Re: Initial Submission Review: Prairie Point Site Plan No 5 – Site Plan and Plat and Plat

Application Number: DA-1609-29

Case Numbers: 2024-4022-00; 2024-3049-00

9 OPEN RAIL FENCE
SCALE: NTS

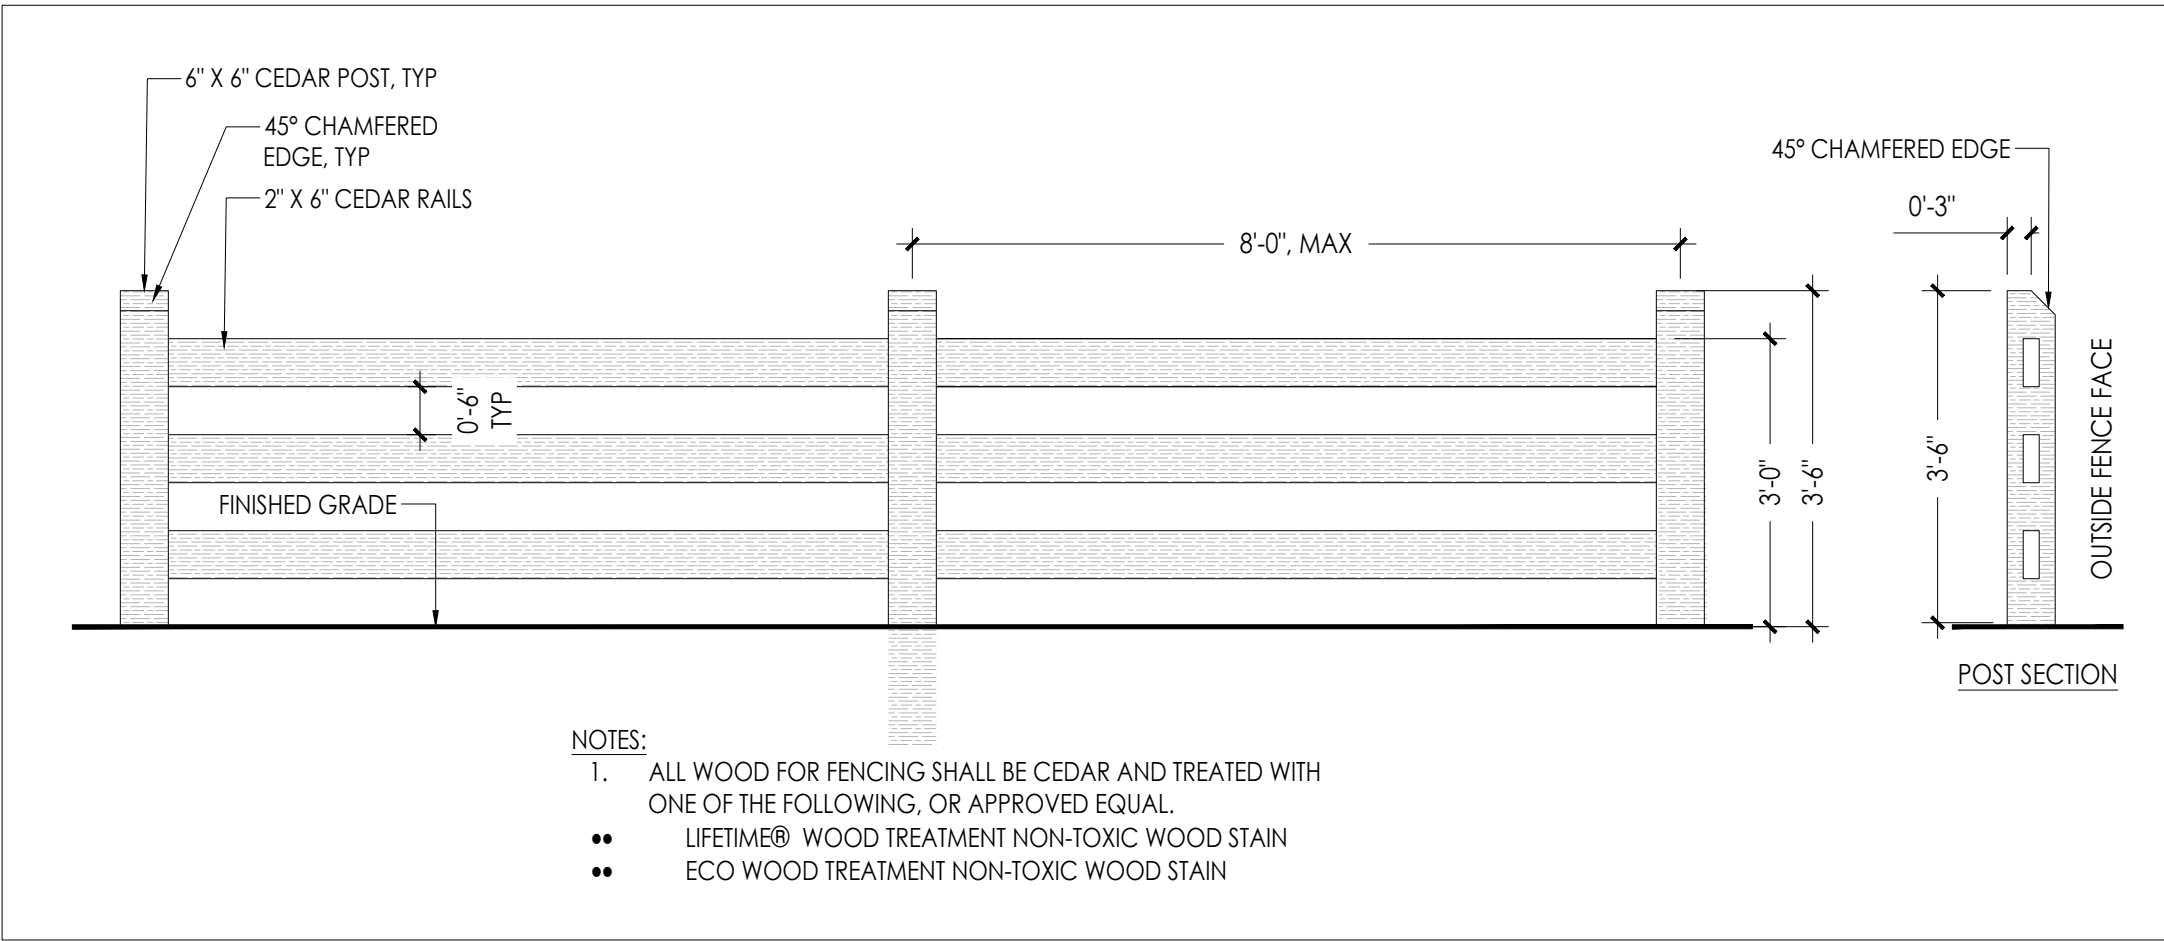
Keep the detail of this fence type if it is intended to be used elsewhere in addition to serving as the standard for the fence parallel to the regional trail. Otherwise, swap this detail out to match PROS' standard detail F-1.0, as that is what should be installed along the trail.

RESPONSE: PROS standard detail F-1.0 has been added to details. This open rail fence detail will be kept as it is still being used on lot.

SHEET 4 OF 5

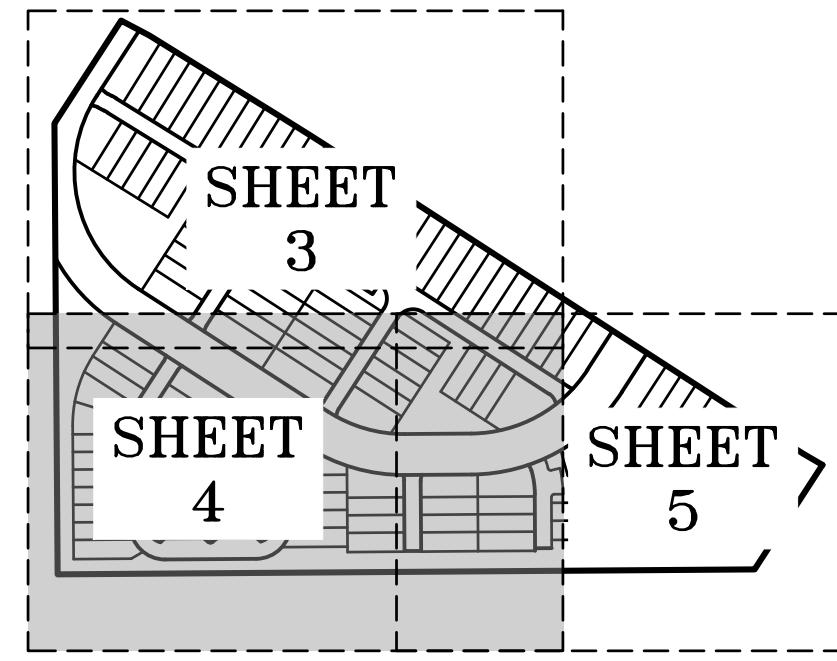
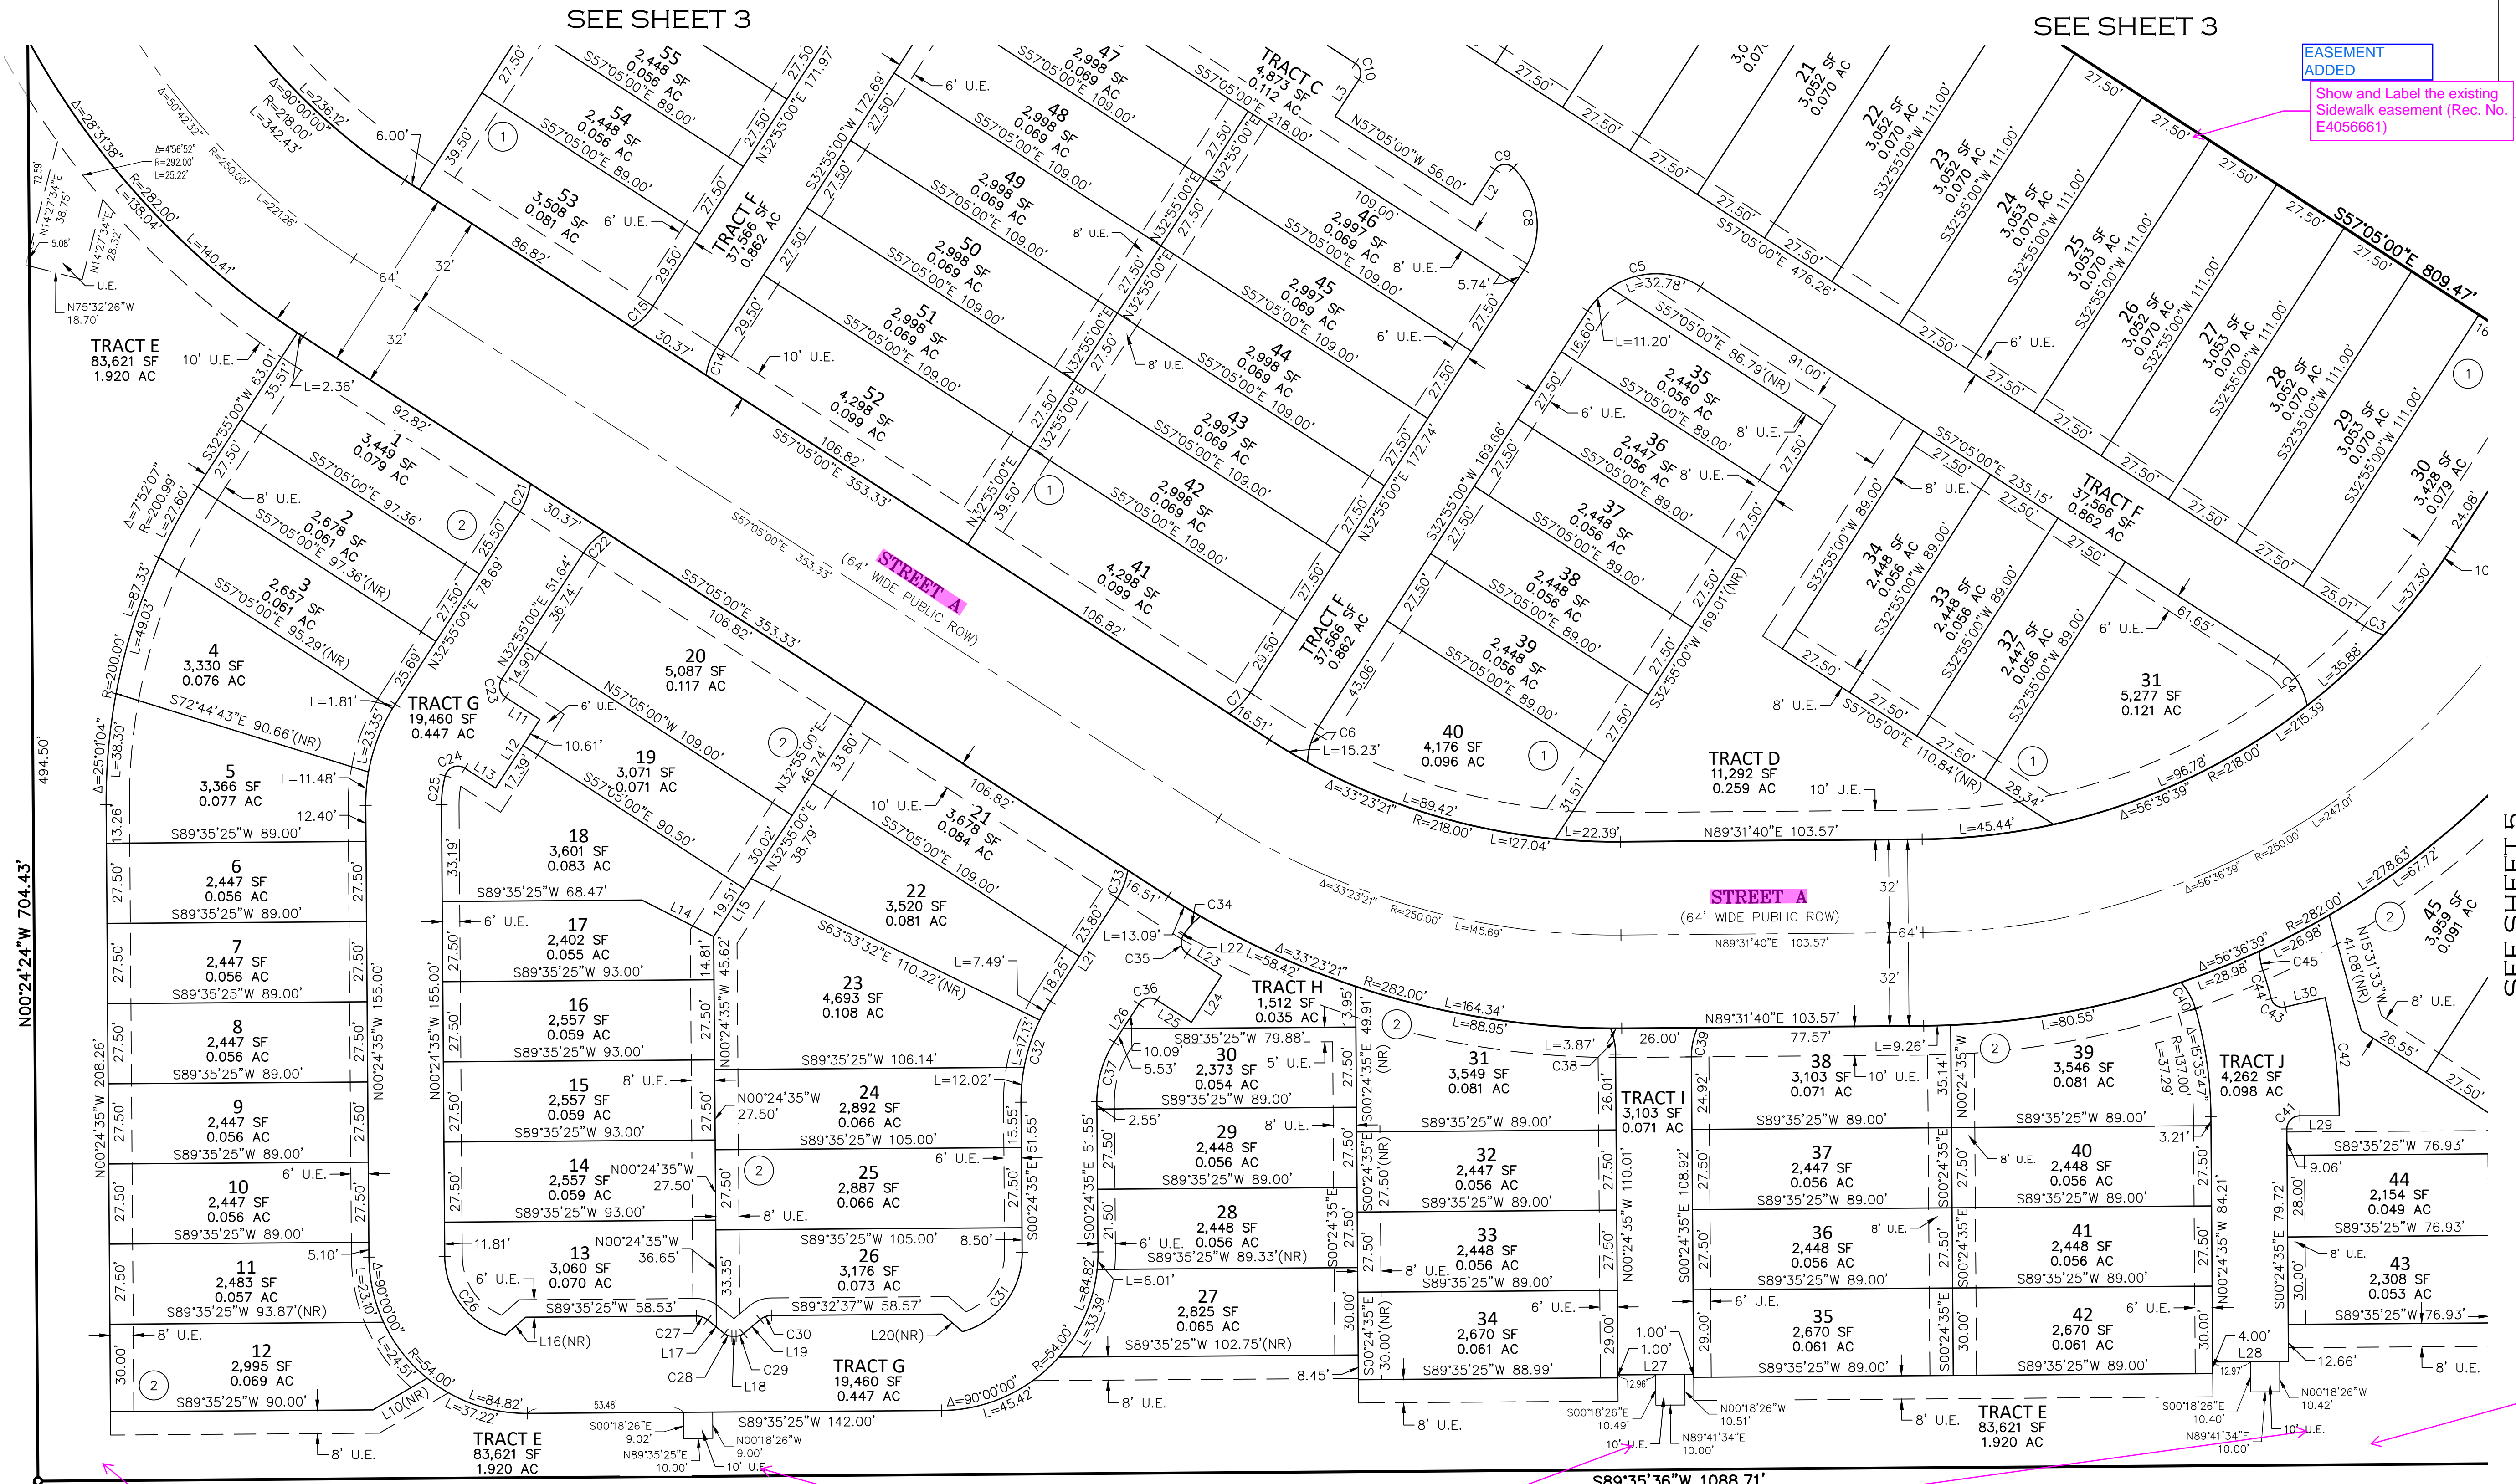
Revise designation to
Storm Sewer
Easement. Update
on Site Plan.

the Site Plan shows a
Regional Trail in this area -
does it need to be added?

EASEMENT
UPDATED
